Development Application No: DA2025/0755 for Alterations and additions to a dwelling house including a garage at 44 Wandeen Road, Clareville.

An assessment has been undertaken of your application. The assessment has found that it is unsatisfactory in its current form for the reasons identified below:

Figure 1: East Elevation - Envelope Breach

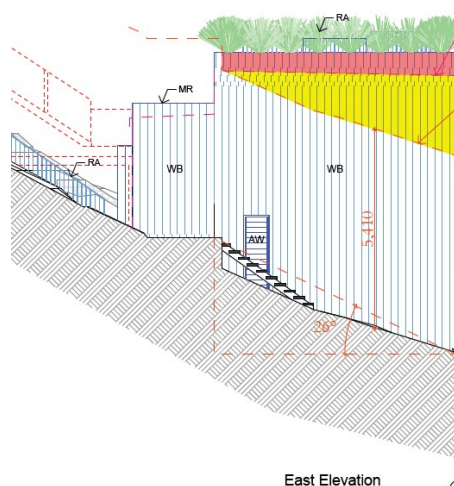
When comparing the development to the usual 3.5m prescribed envelope control, it is evident that a breach will occur to the western garage wall and the eastern side of the dwelling house. Figure 1 below demonstrates the existing breach in yellow due to the existing building footprint. The red shading indicates the new breach to the rooftop terrace.

This rooftop is not supported based on the non-compliance to this control and the visual impacts as discussed in Point 3. The rooftop will not achieve the required outcomes of Clause D1.11 Building Envelope.

The envelope breach to the garage may be supported due to the site constraints.
